UNITED STATES
NUCLEAR REGULATORY COMMISSION
WASHINGTON, D. C. 20555

OCONEE NUCLEAR STATION, UNIT NO. 1

Amendment No. 71
License No. DPR-38

ATTACHMENT TO LICENSE AMENDMENTS

Figure 3.1.2-1A

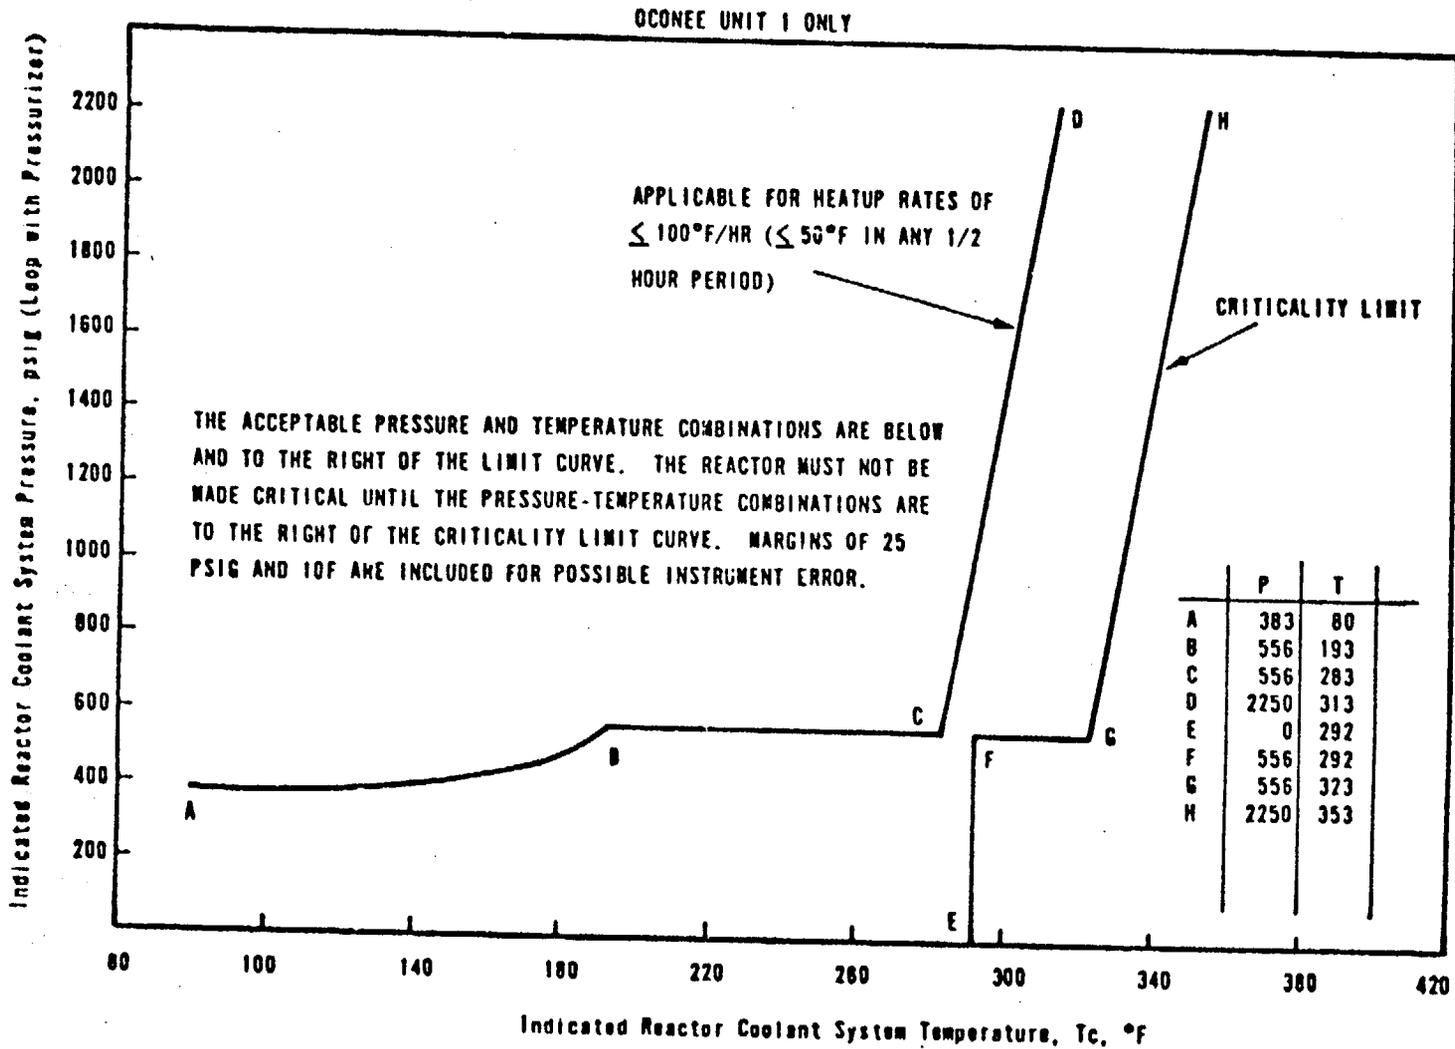
REACTOR COOLANT SYSTEM
 NORMAL OPERATION-HEATUP LIMITATIONS APPLICABLE FOR FIRST
 6.0 EFFECTIVE FULL POWER
 YEARS

We conclude that the proposed pressure-temperature operating limits and changes to Technical Specification 3.1.2 are acceptable but only through 6 EFPY instead of 8 EFPY as proposed by DPC. DPC has agreed to this change. For this operating period the proposed pressure-temperature operating limits are in accordance with the fracture toughness requirements of Appendix G, 10 CFR Part 50. Compliance with Appendix G in establishing safe operating limitations will ensure adequate safety margins during operation, testing, maintenance and postulated accident conditions and constitute an acceptable basis for satisfying the requirements of NRC General Design Criterion 31, Appendix A, 10 CFR Part 50.

Figure 3.1.2-2A

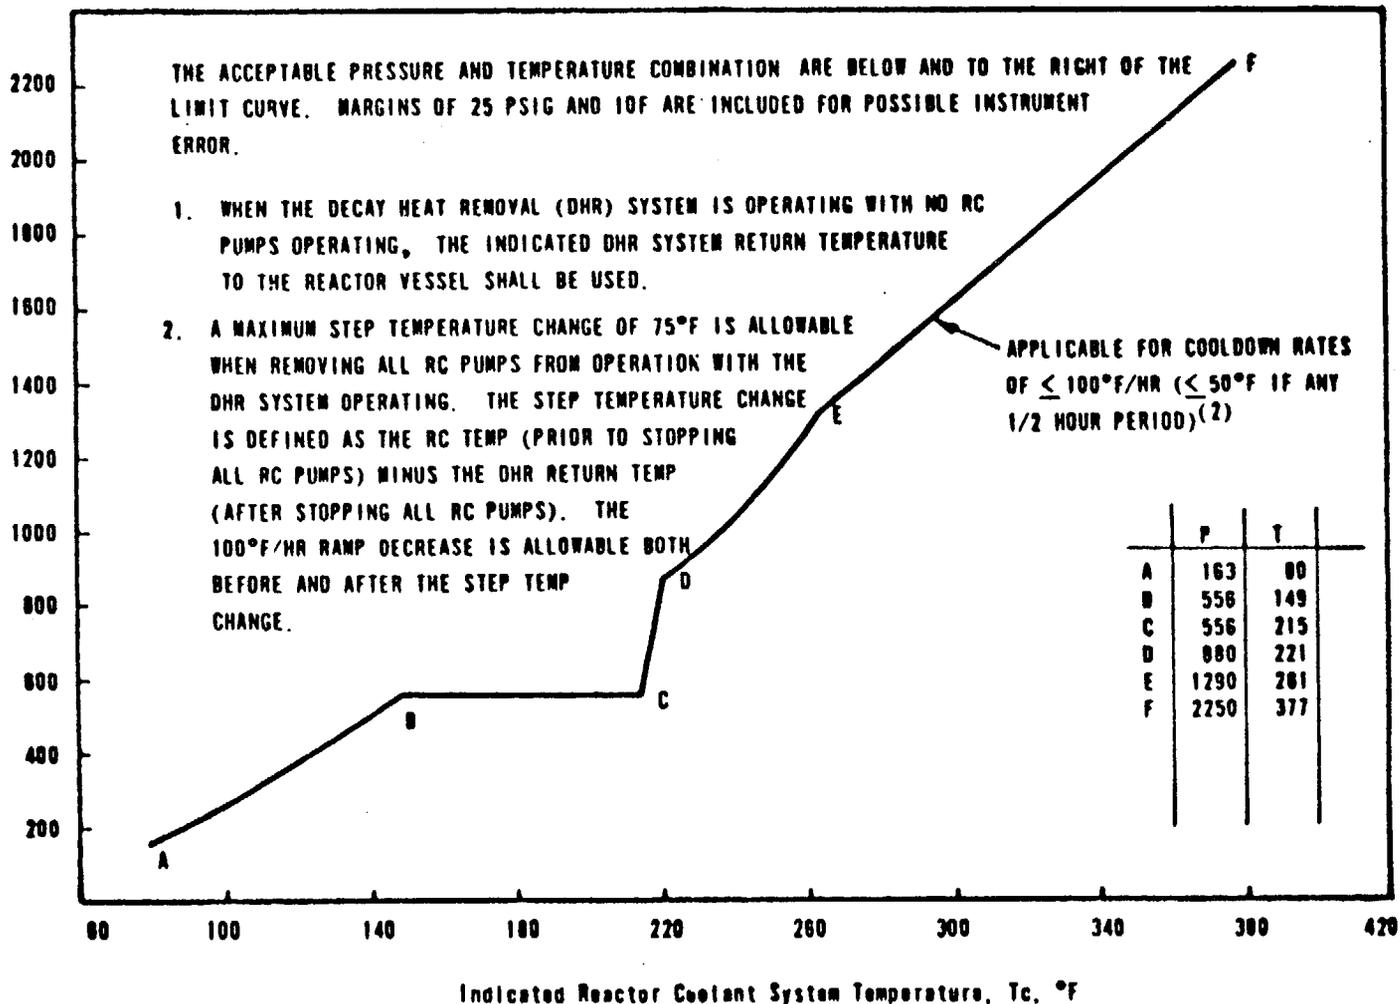
REACTOR COOLANT SYSTEM
 NORMAL OPERATION-COOLDOWN
 LIMITATIONS APPLICABLE FOR
 FIRST 6.0 EFFECTIVE FULL
 POWER YEARS UNIT 1
 OCONEE NUCLEAR STATION

Figure 3.1.2-3A

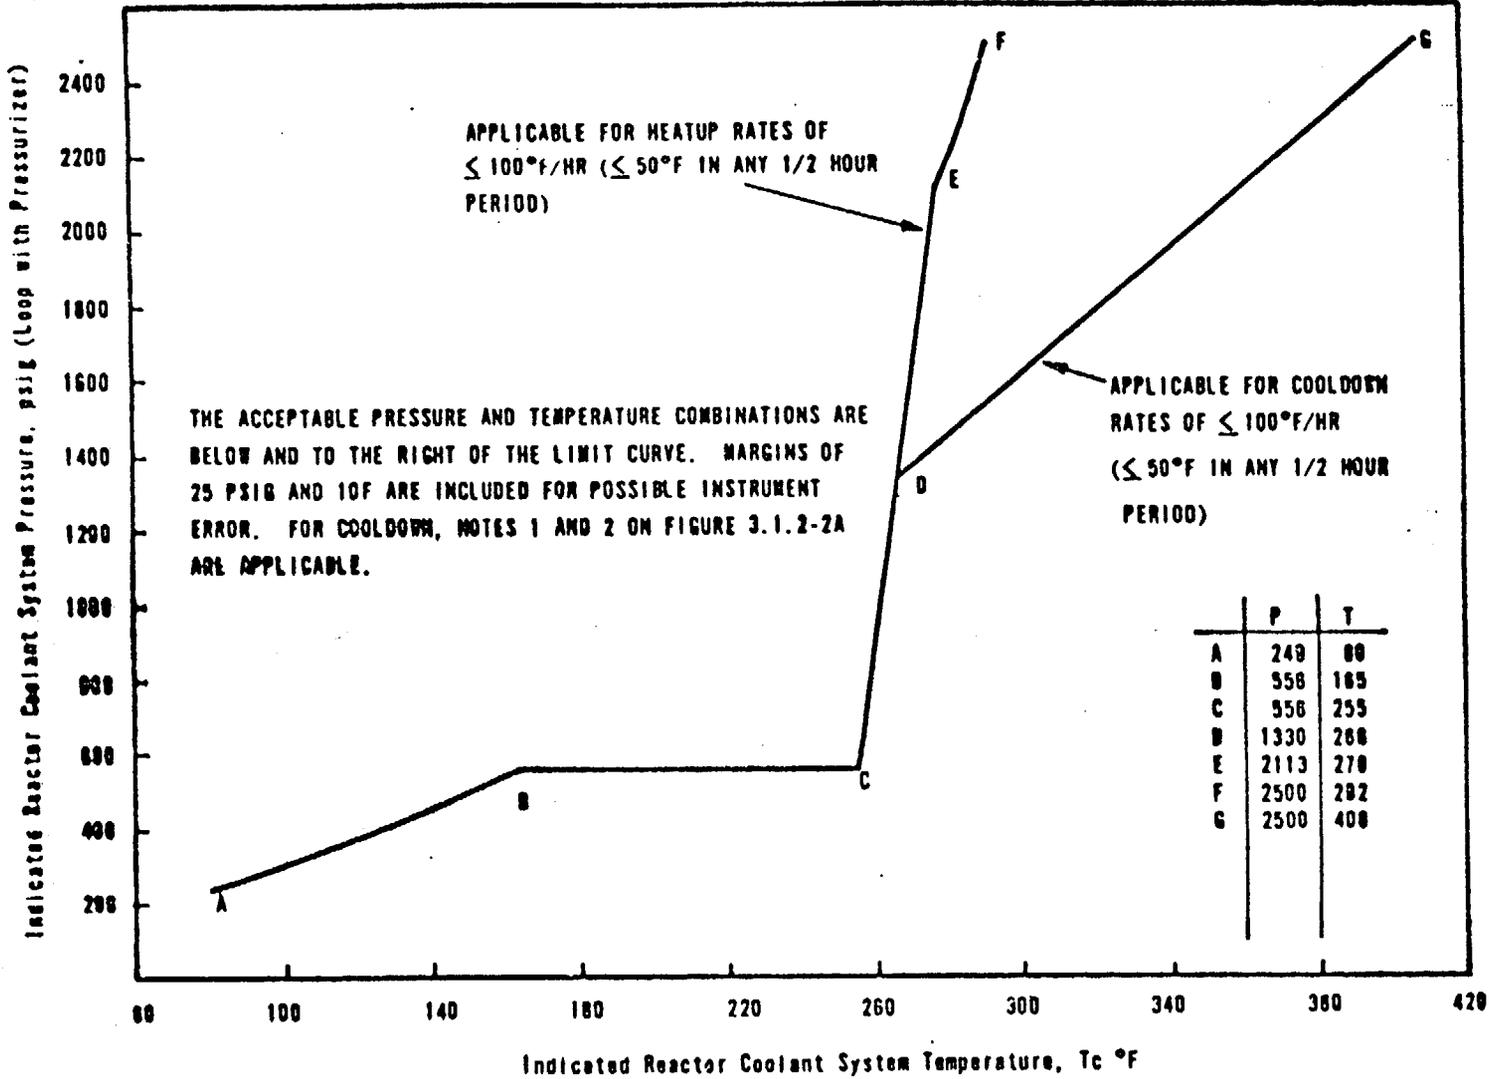
REACTOR COOLANT SYSTEM
 INSERVICE LEAK AND HYDRO-
 STATIC TEST HEATUP AND
 COOLDOWN LIMITATION
 APPLICABLE FOR FIRST 6.0
 EFFECTIVE FULL POWER YEARS
 OCONEE NUCLEAR STATION
 UNIT 1
